Interactive comment on “Niger discharge from radar altimetry: Bridging gaps between gauge and altimetry time series” by Stefan Schröder et al.

Received and published: 23 April 2019

We thank referee 2 for her/his time and effort and for providing constructive comments.

Fig. 2. Rating curves with altimetric heights on x-axis

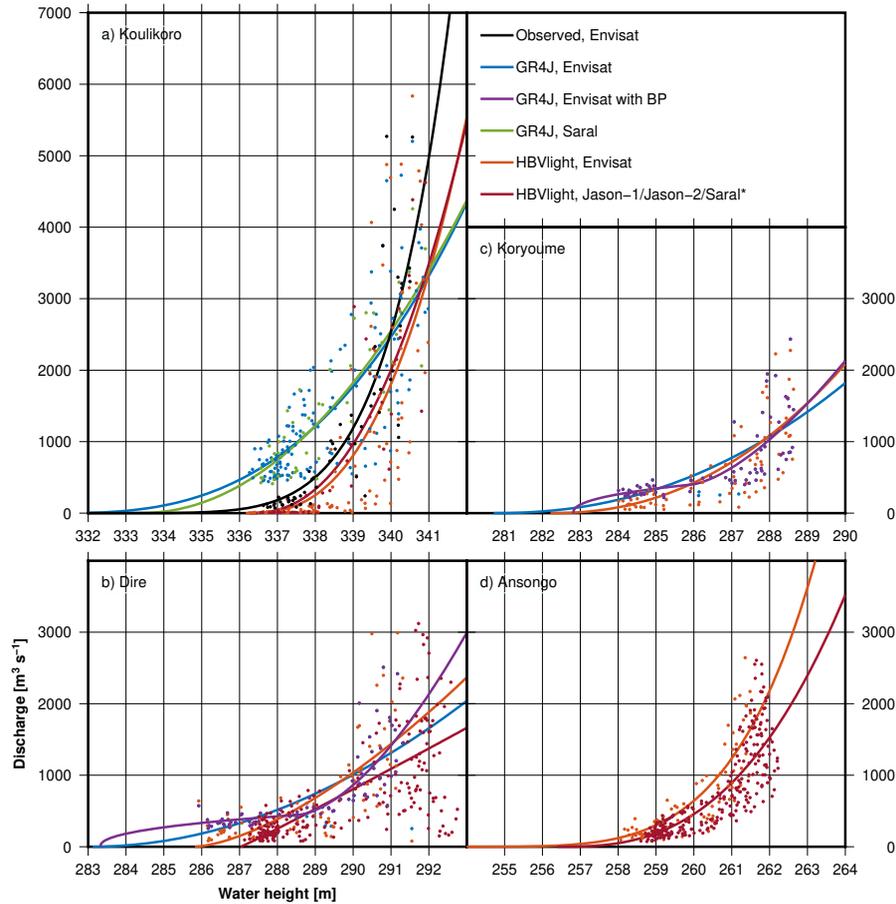
RC: Page 18: Figure 8 is quite difficult to read and I suggest that authors redo it. Actually, it would be more clear to plot the discharge versus the true altimetric height instead of versus the water depth (given that, in addition, no information is provided about the Z_0 parameters). Plotted this way one would have only 2 discharge values for a given altimetric height. Also, information about the Z_0 parameters could be presented simply by the intersection of the rating curves with the height axes.

AR: We changed the figure in the proposed way (Fig. 2) and adapted the discussion

to it.
